Subject: Proposed Technical Specification Amendment for Level 1 position for the University of Missouri – Rolla Reactor Facility, LicenseR-79, Docket 50-123.

The University of Missouri – Rolla Reactor (UMRR) Facility is submitting a proposed amendment to the UMRR Technical Specifications 6.1.2, 6.2, and 6.6.2(3)(c) regarding the Level 1 position. Presently Level 1 is listed as the Dean of the School of Mines and Metallurgy. The University of Missouri – Rolla has made changes to upper administration on our campus and has eliminated the schools and associated deans. UMRR is requesting the Chair of Mining and Nuclear Engineering be the Level 1 position.

Figure 6-1 Organizational structure of the University of Missouri related to the UMR Nuclear Reactor Facility

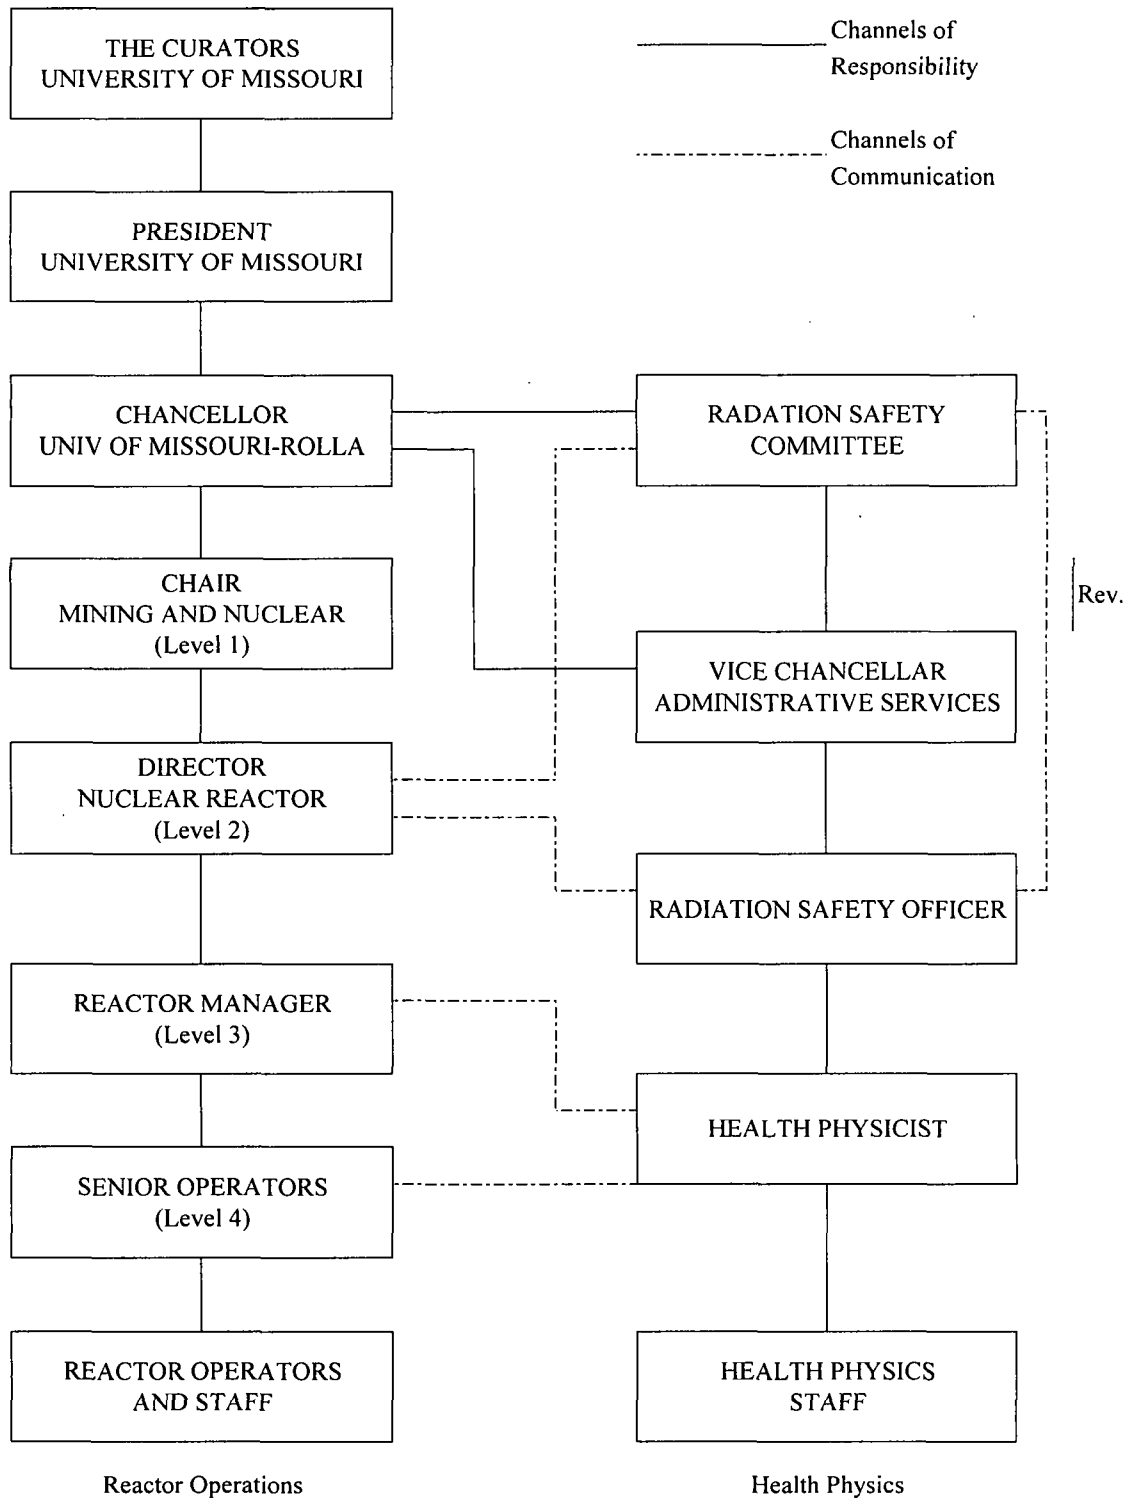
Figure 6-1 lists the Dean of School of Mines (Level 1) in the channels of responsibility.

Figure 6-1 will list "Chair Mining and Nuclear (Level 1)" in place of "Dean School of Mines (Level 1)". Figure 6-1 with this modification is enclosed at the end of this letter. | Rev.
